QUALITY ASSURANCE -- NON-CONFORMANCE REPORT

Location: Changxing Island, Shanghai, P.R. China **Report No:** NCR-000865
Prime Contractor: American Bridge/Fluor Enterprises, a JV **Date:** 16-Oct-2010
Submitting Contractor: Zhenhua Port Machinery Company, Ltd (ZPMC), Changxing Island **NCR #:** ZPMC-0827

Reference Description: Lift 5: North Grillage Cover Plate dimension for Longitudinal Grillage plate do not match with Drawing

To:	AMERICAN BRIDGE/FLUOR, A JV 375 BURMA ROAD OAKLAND CA 95607	Date:	19-Oct-2010
Dear:	Mr. Charles Kanapicki	Contract No:	04-0120F4 04-SF-80-13.2 / 13.9
Attention:	Mr. Thomas Nilsson Project/Fabrication Manager	Job Name:	SAS Superstructure
Subject:	NCR No. ZPMC-0827	Document No:	05.03.06-000822

Report No: NCR-000865

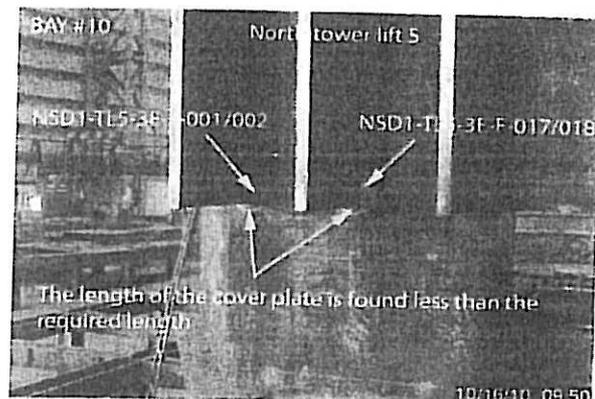
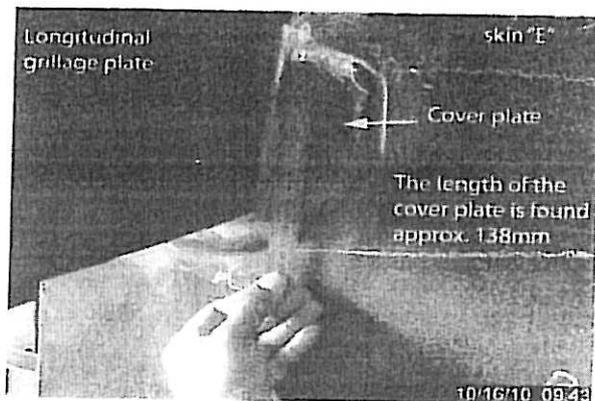
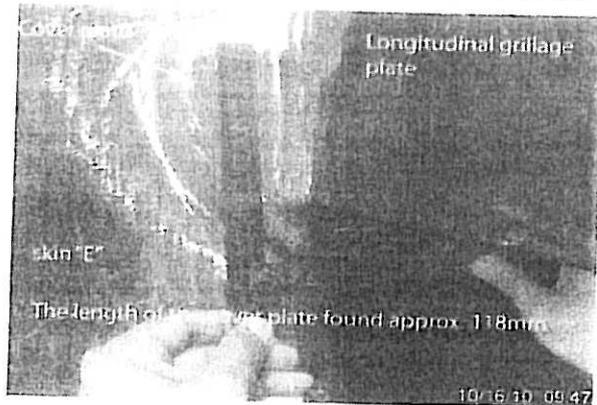
During the Quality Assurance Visual Testing (VT) verification of welds located on Cover Plate for the Longitudinal Grillage plate of North Tower lift 5, this Quality Assurance (QA) Inspector discovered the following issues:

- The dimensions of Cover Plate do not match the approved shop drawings.
- As per shop drawing the required length of the Cover Plate is 151.4mm.
- Cover Plate weld # NSD1-TL5-3E/F-001/002, the length of the Cover Plate was measured as 138mm.
- Cover Plate weld # NSD1-TL5-3E/F-017/018, the length of the Cover Plate was measured as 118mm and 143mm.
- These welds are fillet welds, joining the Cover Plate to the Skin Plate and Longitudinal Grillage plate.
- The member is located in Bay 10.

Contractor will submit revised shop drawing as per the as built for Engineer's approval. Ensure in future to communicate with CT before any modification works are performed.

Contractor has revised the shop drawing and submitted for Engineer's approval. The revised drawing has been accepted and the cover plate left as- built.

Report No: NCR-000935

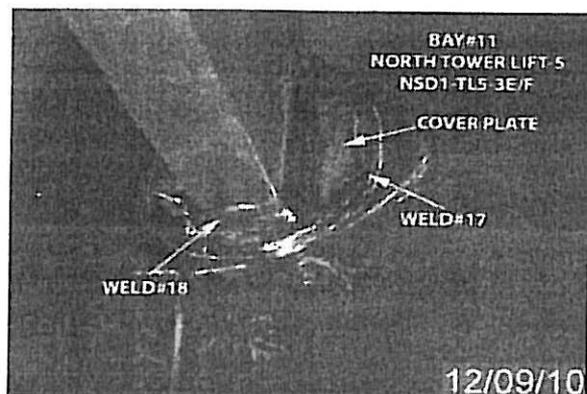
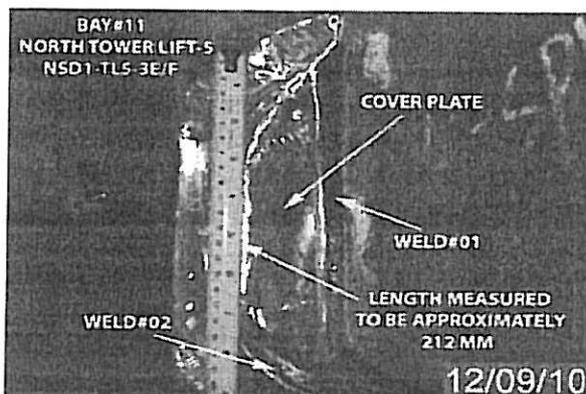
During the Caltrans Quality Assurance (QA) in-process observation on North Tower Lift 5 Cover plate, this QA Inspector discovered the following issue:

- ZPMC fabrication personnel removed 2 cover plates involving a total four (4) Non-SPCM fillet welds without notifying the Engineer .
- ZPMC re-welded with new cover plates, where the dimension of the cover plates does not comply with the approved drawings.
- As per the shop drawing the required length of the cover plate is 151.4 mm. The length measured was approximately 212 mm.
- Welds are fillet welds joining cover plate to skin 'E'.
- The weld designations are NSD1-TL5-3E/F#01; 02; 17; 18.
- This component located at fabrication Bay#11.
- NCR ZPMC-827 had been issued on 10/19/2010 for the two non-conforming cover plates that were removed. Response to this NCR is still outstanding todate.

Here we clarify as below, as ZPMC got the oral agreement "RFF" drawing, so it was thought can be used without submitting formal documentation, but actually it should be. So it was a misapprehension, in the future we will take more care and make more communication with each other to avoid such problem. As a result the drawing was approved by Engineer and welds were accepted and green tagged.

Report No: NCR-000936

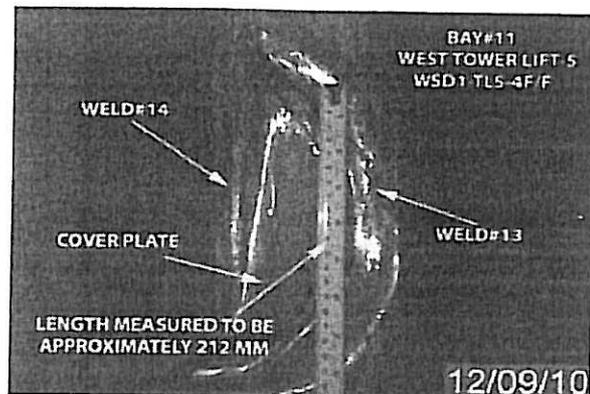
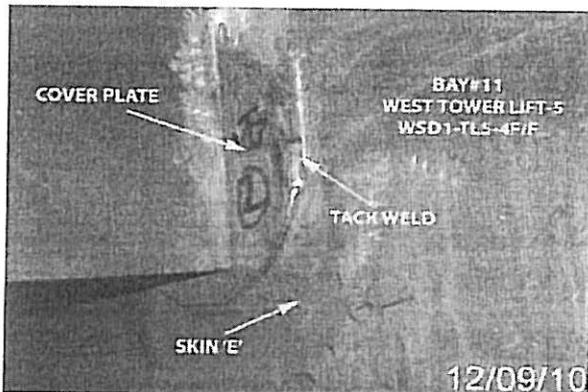
During the Caltrans Quality Assurance (QA) in-process observation on West tower lift-5 Cover plate, this QA Inspector discovered the following issue:

- ZPMC fabrication personnel removed 2 cover plates involving a total four (4) Non-SPCM fillet welds without notifying the Engineer.
- ZPMC re-welded with new cover plates, where the dimensions of the cover plates do not comply with the approved drawings.
- As per the shop drawing the required length of the cover plate is 151.4 mm. The length measured was approximately 212 mm.
- Welds are fillet welds joining cover plate to skin 'E'.
- The weld designations are WSD1-TL5-4F/F#13; 14; 15; 16.
- This component located at fabrication Bay#11.
- NCR ZPMC-827 had been issued on 10/19/2010 for the two non-conforming cover plates that were removed. Response to this NCR is still outstanding today.
